NSR Technical Notice

NSR23-TN01

New firmware for NHR-1500 MF/HF Radio.

2.1 Transmitting via DSC

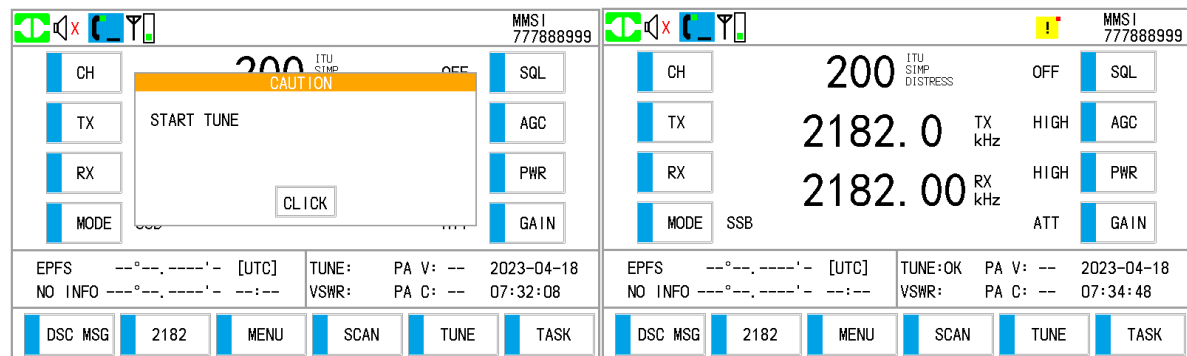
When a DSC call is initiated on a new frequency (different from previous transmission), "START TUNE" window in Control Unit screen will pop up to suggest tuning in process at antenna coupler. After 2 seconds, the caution window will automatically disappear if tuning has been successfully completed, and the DSC call will be transmitted at HIGH power. Otherwise, "TUNE NG/ERR" window will pop up, and the DSC call will be transmitted at LOW power.

2.2 Transmitting via SSB

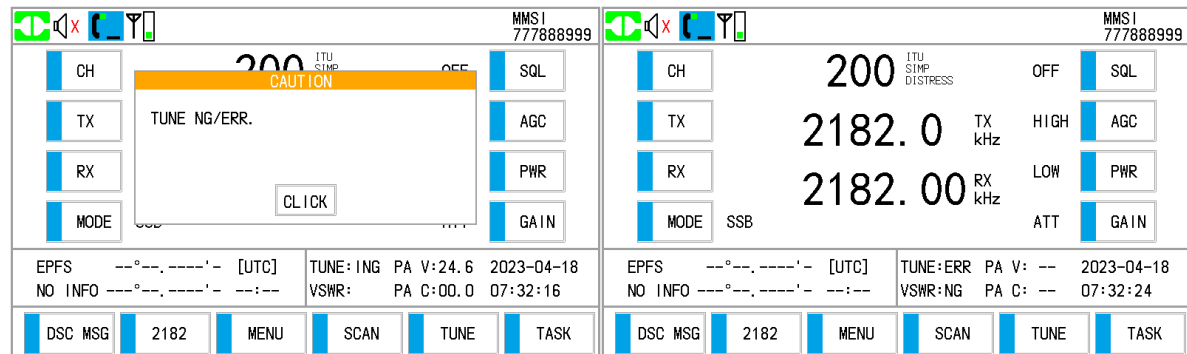
When a SSB voice call is initiated on a new frequency (different from previous transmission) by selecting power at HIGH or MED, "START TUNE" window in Control Unit screen will pop up to suggest tuning in process at antenna coupler. After 2 seconds, the caution window will automatically disappear if the tuning has been successfully completed, and the SSB call will be transmitted at HIGH power.

Otherwise, "TUNE NG/ERR" window will pop up, and the SSB call will only be transmitted at LOW power.
